# Bradley Heights Apartments

## A 236-Unit Apartment Development Puyallup, Washington

### Bradley Heights SS LLC

1-BED-INT-1 UNIT TYPE 'B' ACCESSIBLE  
BASEMENT & 1st LEVEL FLOOR PLAN  
1/4" = 1'-0"

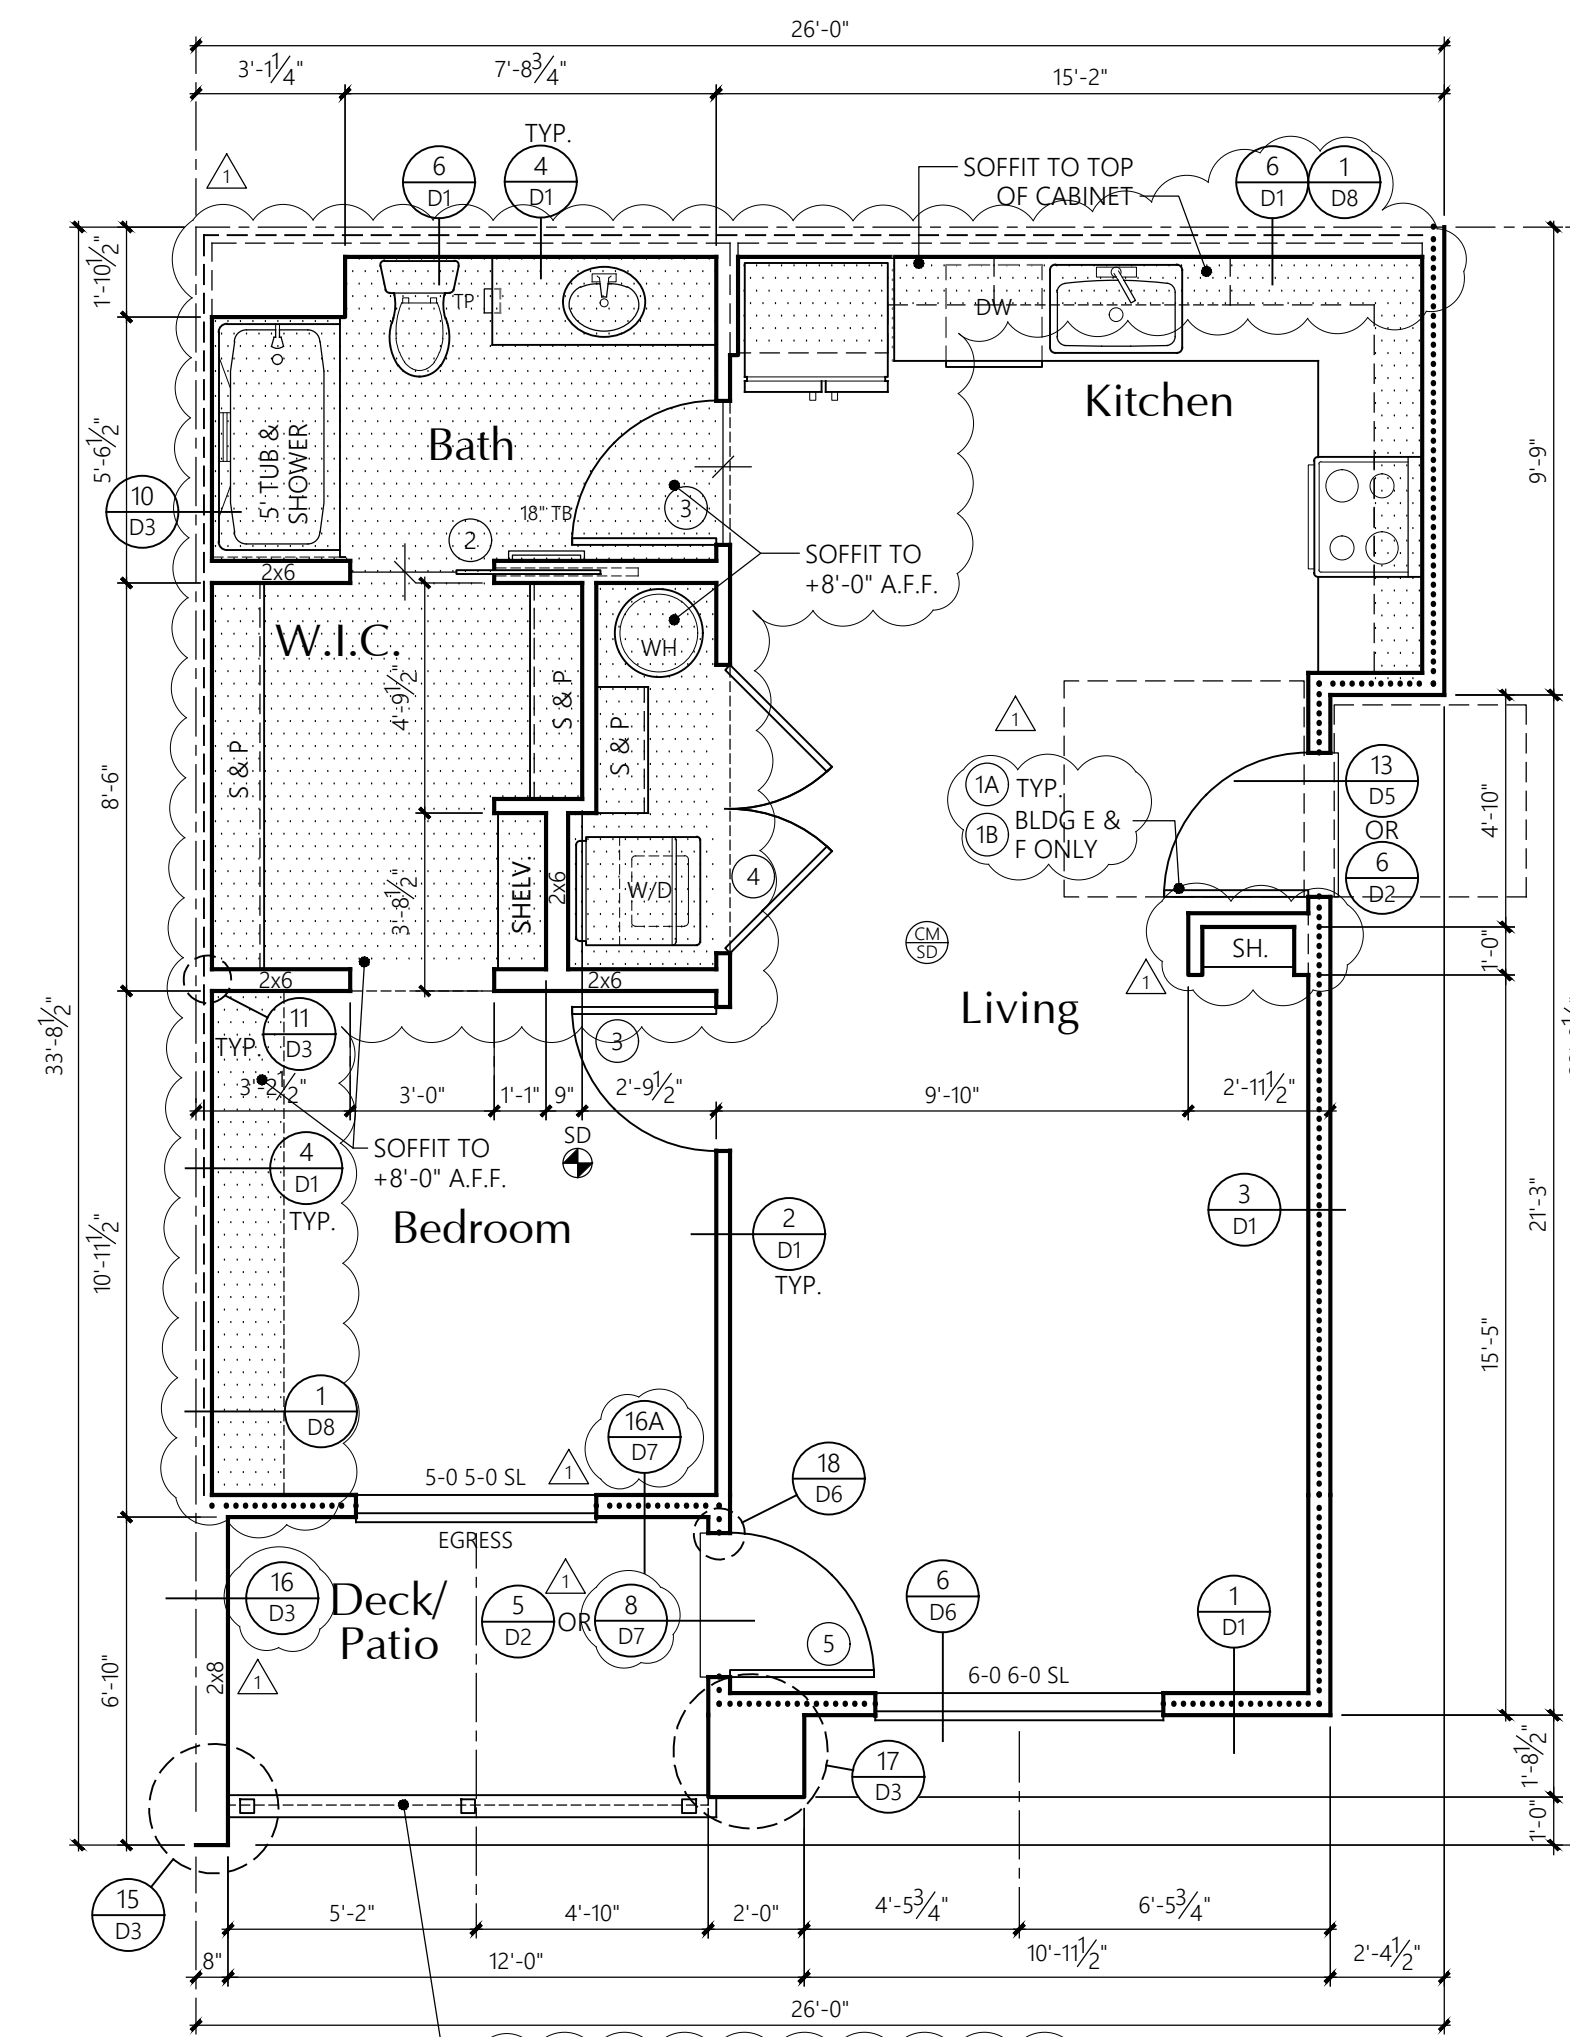
Door Key references Sheet U13 update plan or sheet numbers as needed, as there is no Sheet U13.

**2 BED UNIT** TYPE 'A' ACCESSIBLE 1st LEVEL FLOOR PLAN  
1/4" = 1'-0"

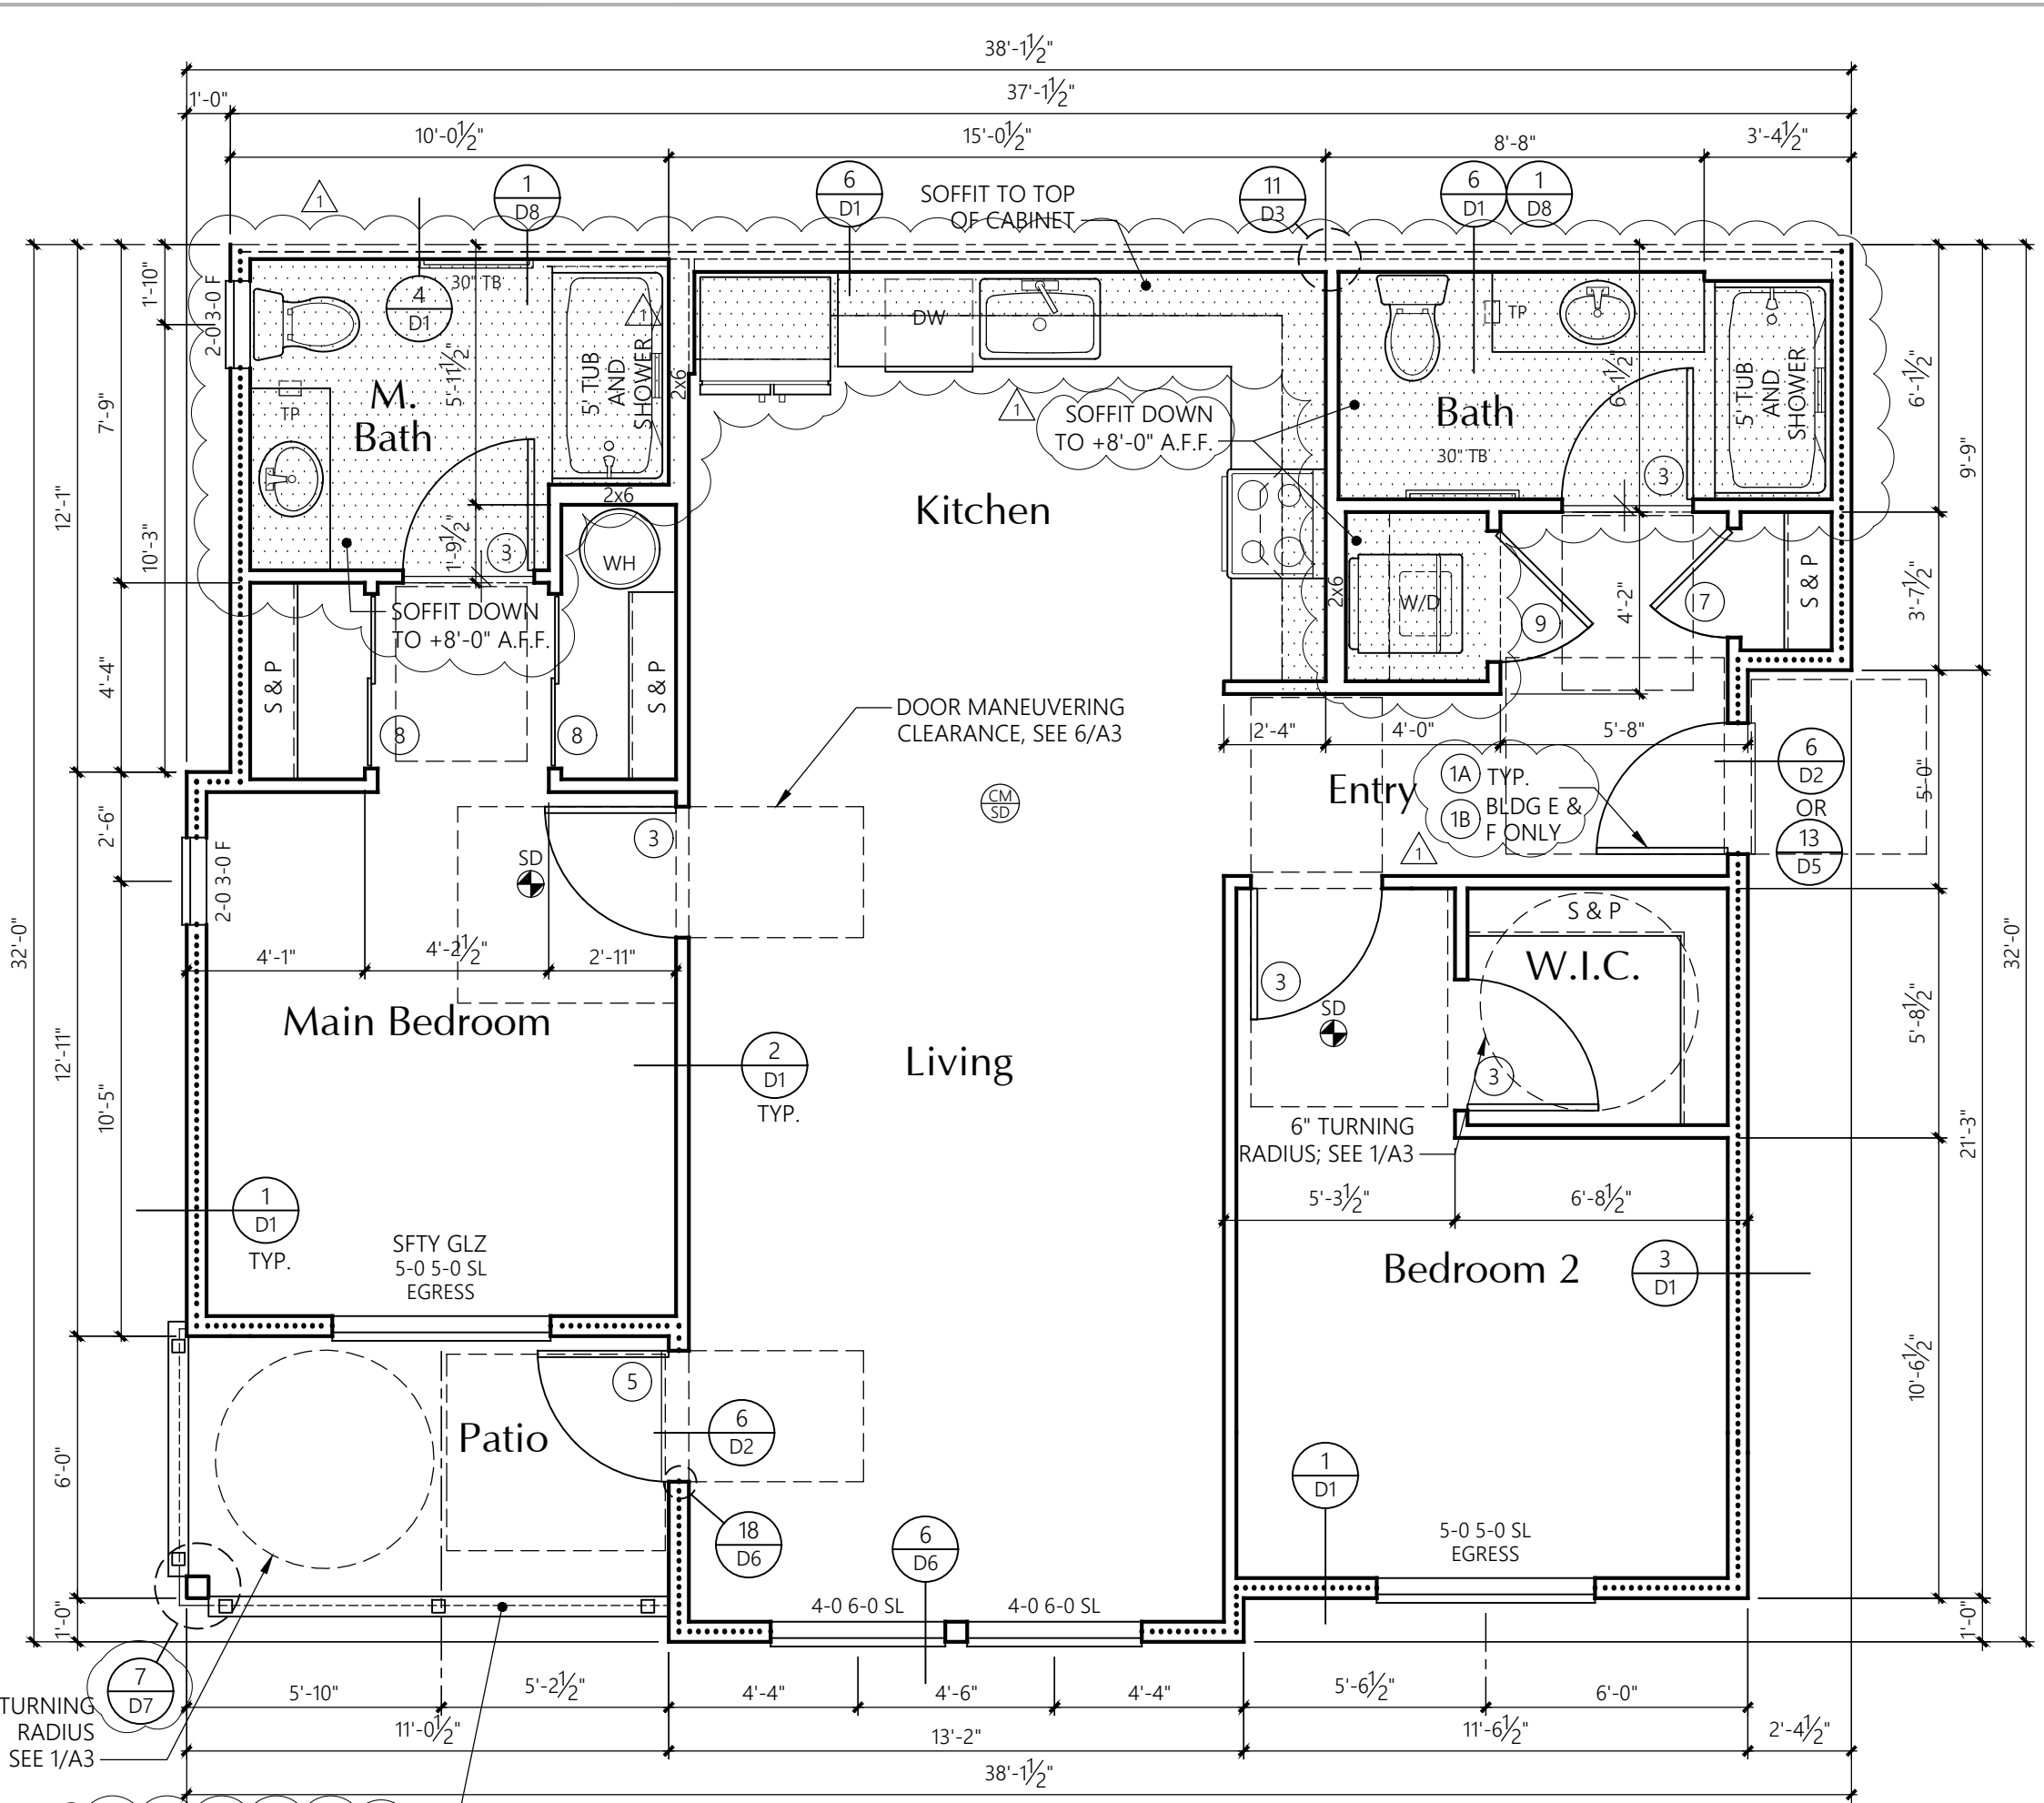
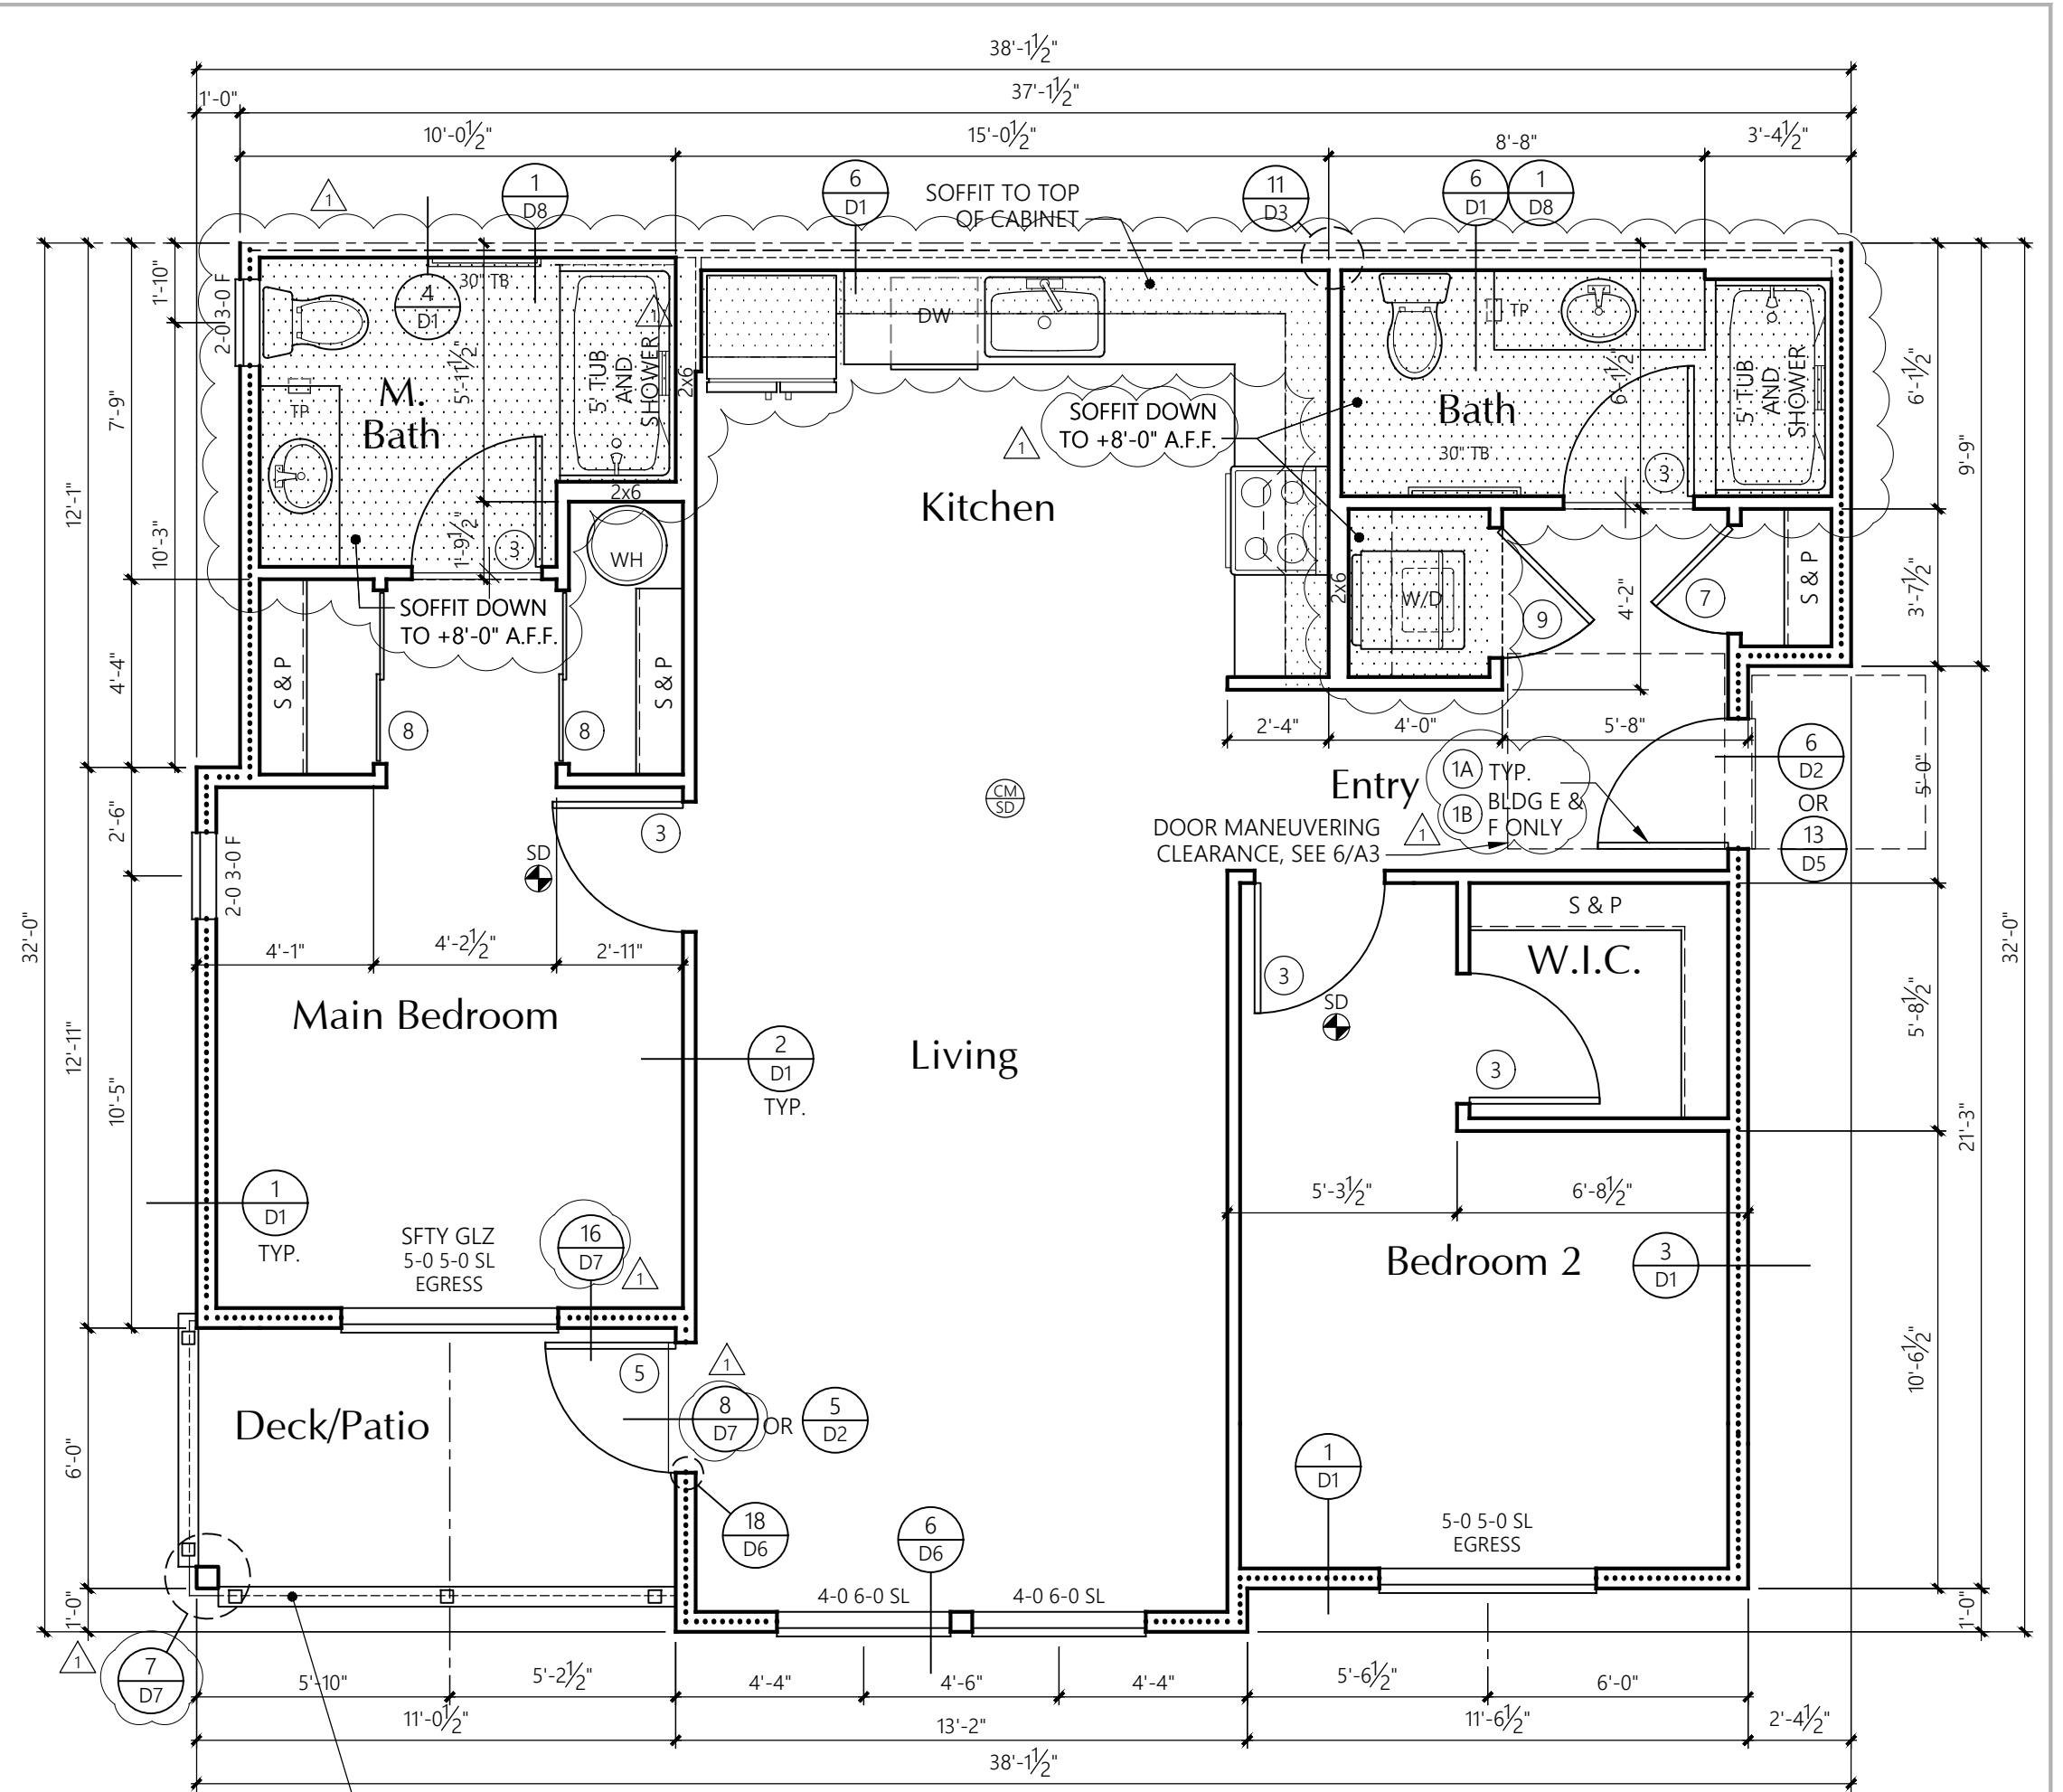
Review and clarify instances where header height will change as the header height is called out as 8' U.N.O. in Unit Plan Notes. Example 2 Bed Unit on Sheet U4 has a furred down ceiling. Review other units for additional instances and adjust if necessary.  
**(Construction Set, Sheet U1-U5.1, Unit Plan Notes)**

Review and clarify how washer and dryer in all Type A units shall meet Washington Accessibility Code 2009, Section 611. Example 2 Bed Unit shows a washer and dryer that appear to be stackable which could put the loading openings outside the perimeters set by 611.4. Review and updated as needed.  
**(Construction Set, Sheet U1-U6, Unit Plan Plans)**
